7100 Wisconsin Ave, Project Plan, 920130010

The Applicant submitted two plans. The first plan shows a 90-foot tall building of uniform height similar in mass and form to the existing residential building on the block. The second and alternative plan (**Alternative**) has a smaller footprint and more open space, with height stepping from 120 feet to 45 feet. The recommendation is for DENIAL of the 90-foot tall building of uniform height, and APPROVAL of the Alternative, with conditions. The **Alternative** was submitted in response to the residents of the adjacent Crescent Plaza condominium who requested a reduction in impacts on their light, air, privacy and views. The alternative achieves that reduction in impacts, and maintains the same yield as the **Proposed Development**. This is achieved by replacing a portion of the proposed building with landscaped open space and dropping the height of part of the building. The design recoups square footage by increasing the building height along Wisconsin Avenue. However, the height is greater than that recommended in the Sector Plan but remains in conformance with the zone. The Applicant chose to show both to keep the review process movi

Proposed Development: Diagram of Public Open Space

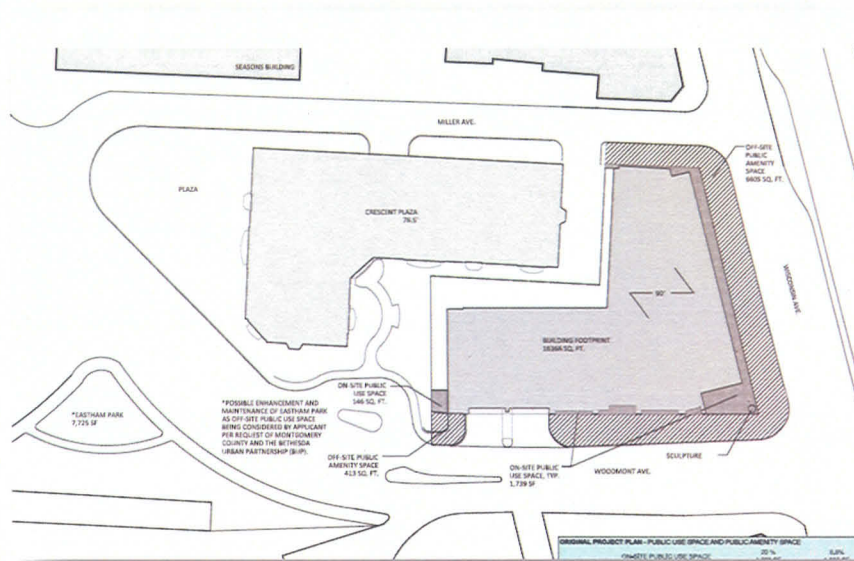
projects, but there is a requirement for the provision of a minimum of 20% of the net lot area to be devoted to public use space. The Proposed Development satisfies by providing a small amount of public use space on-site coupled with enhancements to off-site public spaces within the pedestrian areas of public right of way. The maximum FAR for optional method projects in the CBD-R2 Zone is 5 FAR; however, the Sector Plan recommends a 3 FAR. The proposal is for 3.63 FAR incorporating a 22 percent density bonus, which is well within the range of the zone.

Alternative: Diagram of Public Open Space

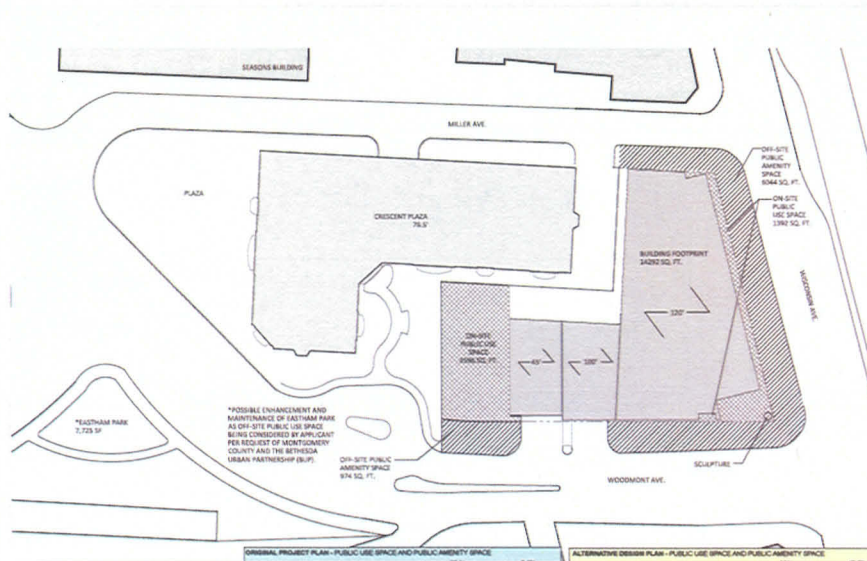
The **Alternative** differs from the **Proposed Development** in that it includes more public use space on-site. That additional space is located next to the existing public space of the adjacent

Elevation of the proposed building (left) and massing study of the proposed building adjacent to the existing Crescent Plaza building

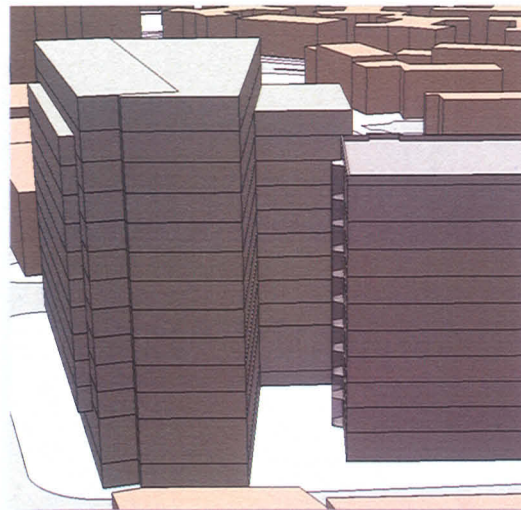
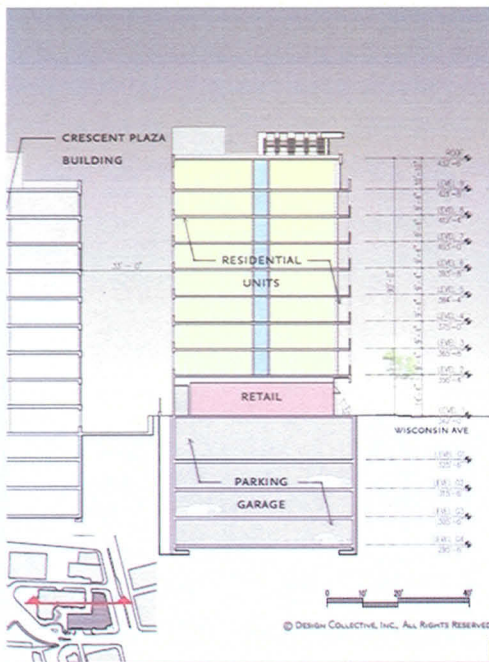
The east side of the Crescent Plaza building is separated from the proposed building by approximately 30 feet in both the **Proposed Development** and in the **Alternative**. There should be a design that contributes to a more desirable relationship between the two buildings and their windows and any proposed balconies. The following images include a section showing the separation, and a graphic representation of the relationship of the proposed building massing to that of the existing Crescent Plaza building. The Crescent Plaza building has units with windows facing the proposed building. The Crescent Plaza is set back approximately 20 feet from the shared property line and the units overlook access drive to their own building’s loading area.

Additional design features on the east side should be incorporated to produce a better relationship with Crescent Plaza. For lower levels, trees and tall shrubs to screen views are an obvious solution. However for the upper levels, other strategies should be considered to create a more desirable relationship between the buildings. At the time of site plan review, this should be addressed. One approach is to replace or diffuse views from windows and balconies that are facing one another. Good air circulation should be a goal, and it will reduce energy expended for climate control. In the same vein, the design solution should maximize natural light. Consideration should be given to creative solutions that are attractive and integrated. Consideration should be given to creating an attractive green screen.

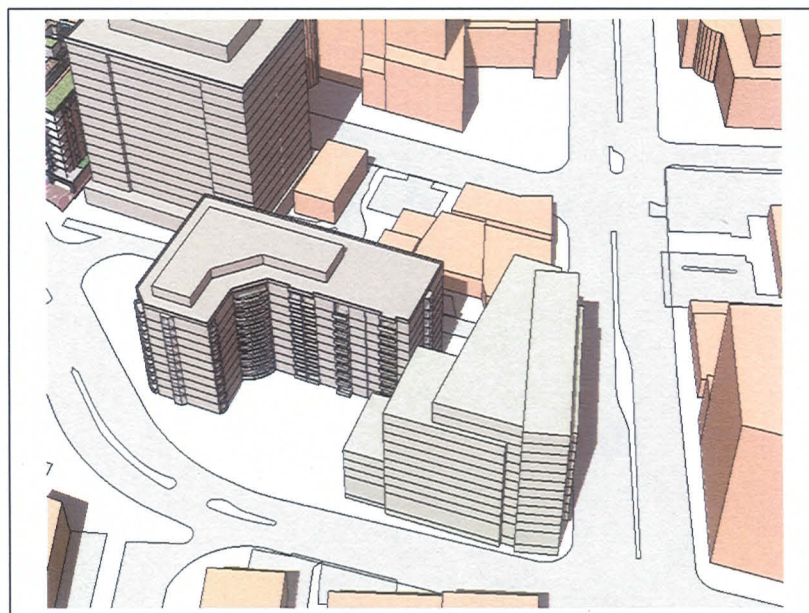
Illustration below: In the mid spring and mid fall, at NOON, the east facing units are still in shade; however all the south facing units have sunlight as does the entire open space facing Woodmont Avenue. The sidewalk on the east side of Wisconsin Avenue is in the sun, and the west side is in shade. The sidewalk along Woodmont Avenue is in the sun.

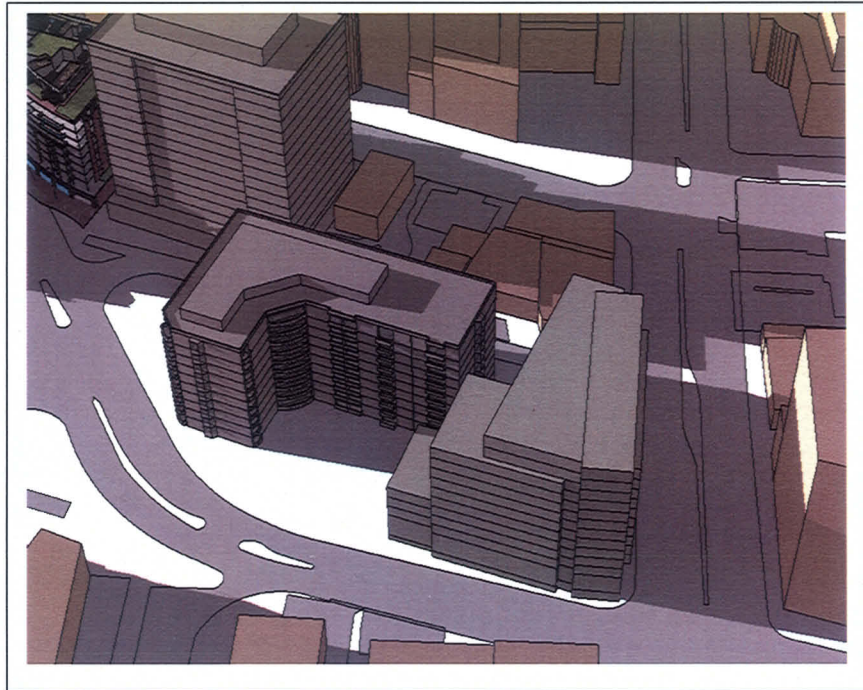
Illustration below: In mid-spring and mid-fall, at 5 PM when many people are returning home from work or going out for the evening, there is still sunlight on the open space facing Woodmont Avenue. However the Crescent Plaza south-facing units are in the shade of a wing of their own building. The Wisconsin Avenue sidewalks are already in shade as well. The sidewalk along Woodmont Avenue is in the sun contributing to a comfortable walk to and from the Metro Station, and restaurants and shops.

Uniform 9-Story Plan as Originally Presented to CP:

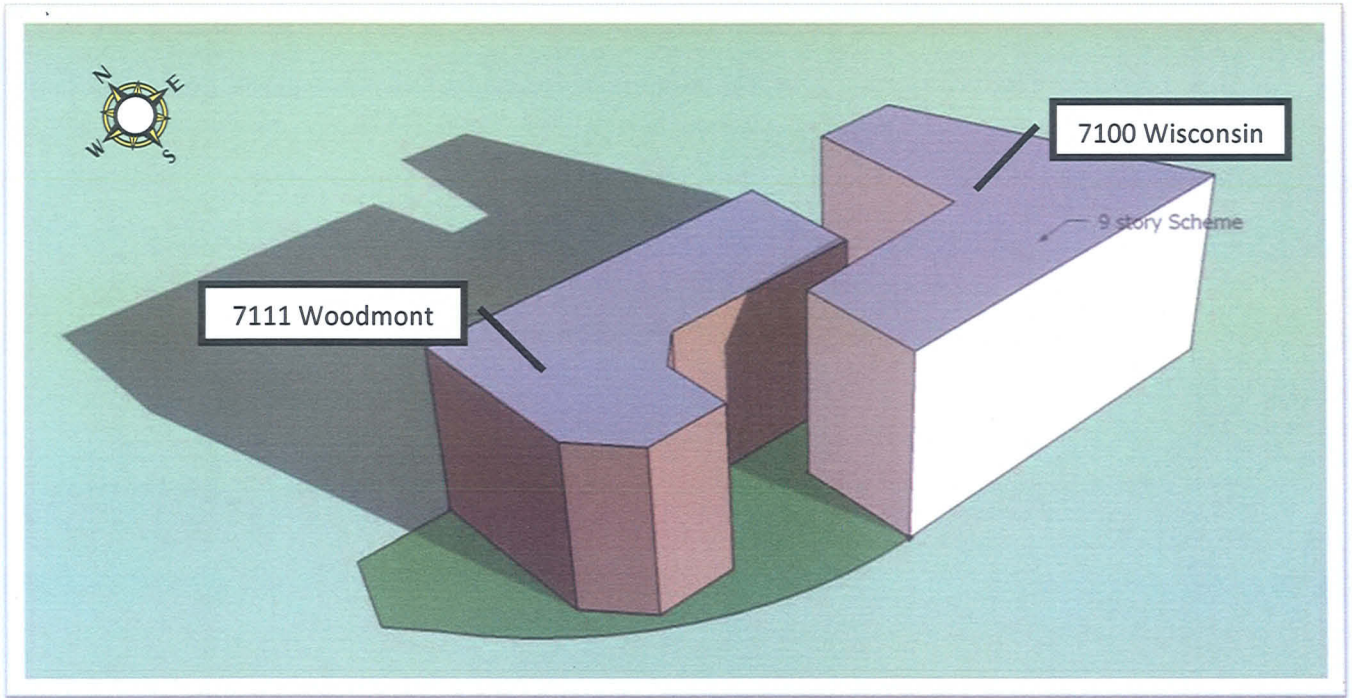
If the proposed uniform 9-story, L-shaped plan (Project Plan Application Number 920130010) for 7100 Wisconsin Avenue is approved and built, 24 condominium units in Crescent Plaza (CP) will be completely blocked by the new development (CP Tiers 15, 17, and 18 – see Crescent Plaza diagram below), and 44 additional Crescent Plaza units will have a direct view of the back of 7100 Wisconsin (CP Tiers 01, 04, 09, 11, and 13). This plan for the uniform 9-story building will result in:

With that said, the following is a rough representation of the 9-story plan (Application Number 920130010) showing how 7100 Wisconsin would completely block sunlight to almost a quarter of CP units for all or a majority of the day (depending on unit location). This plan provides no mitigation for the loss of light to CP and is unacceptable to the CP owners and residents identified on the attached list.

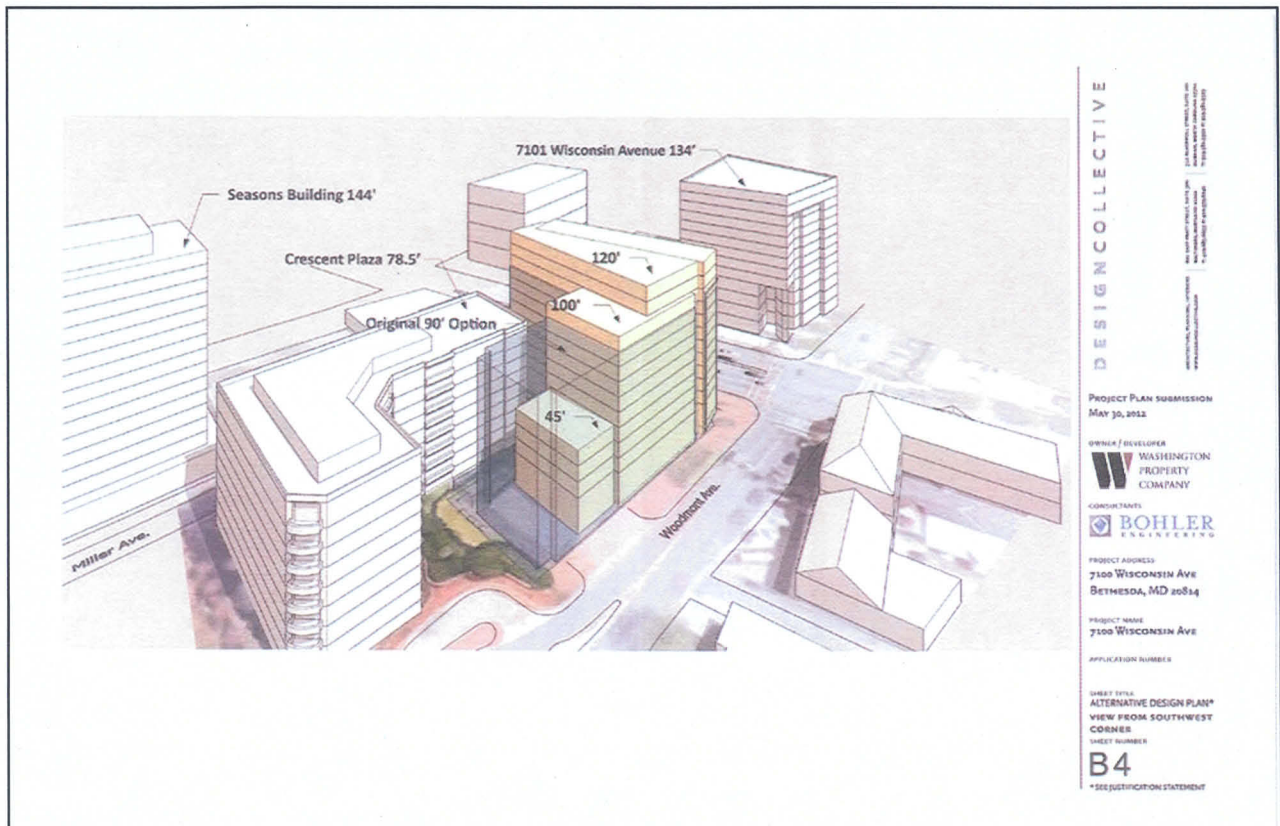
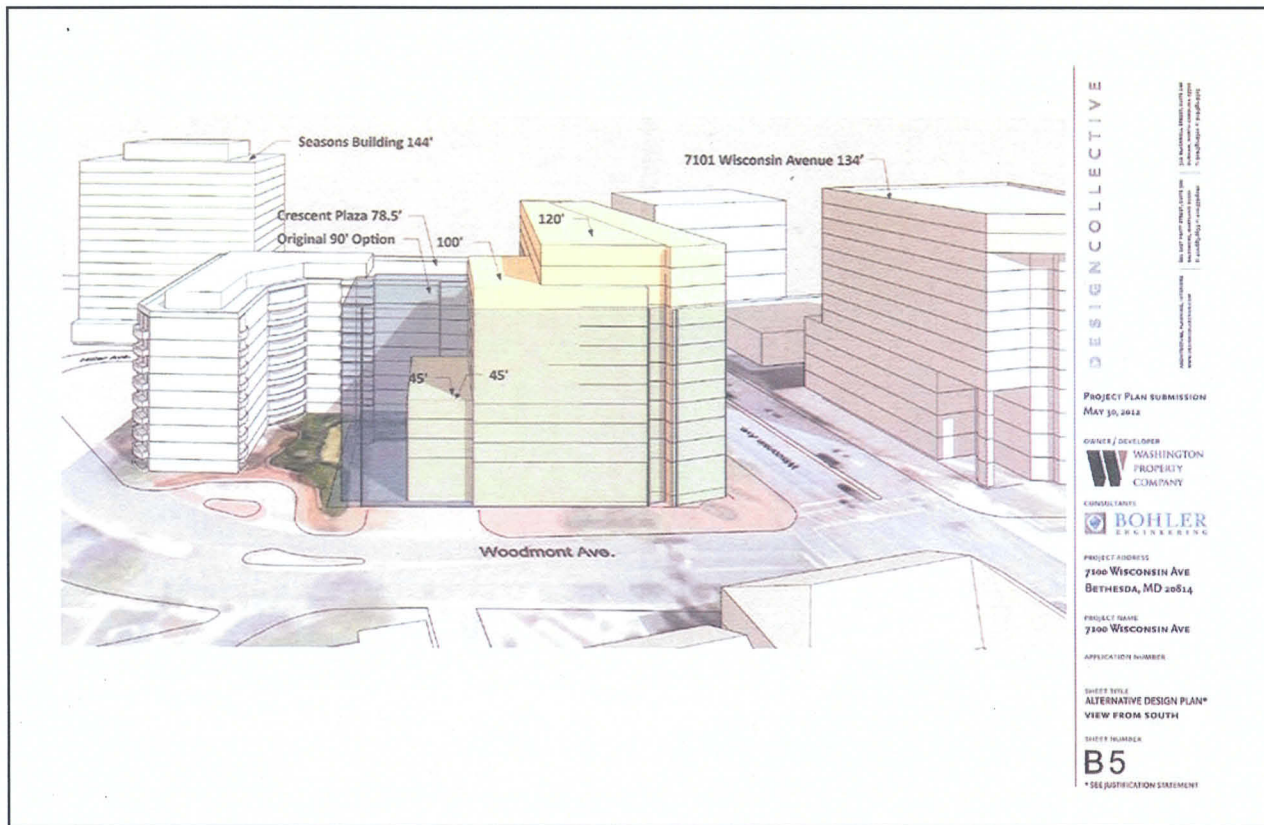
The Alternative Plan Design submitted under Application Number 920130010 is our second choice and would be an acceptable solution. This is a 12-story, 120 foot building that steps down to 10 stories and then 4 stories. With this approach, the loss of sunlight (natural light) will be significantly reduced for those CP units most directly affected by the development. The rough diagram below provides a representation of the affects of this alternative plan on light to CP.

Below is this alternative design plan as represented by Washington Property. Again, it is evident that with this design, CP is afforded significantly more direct sunlight.
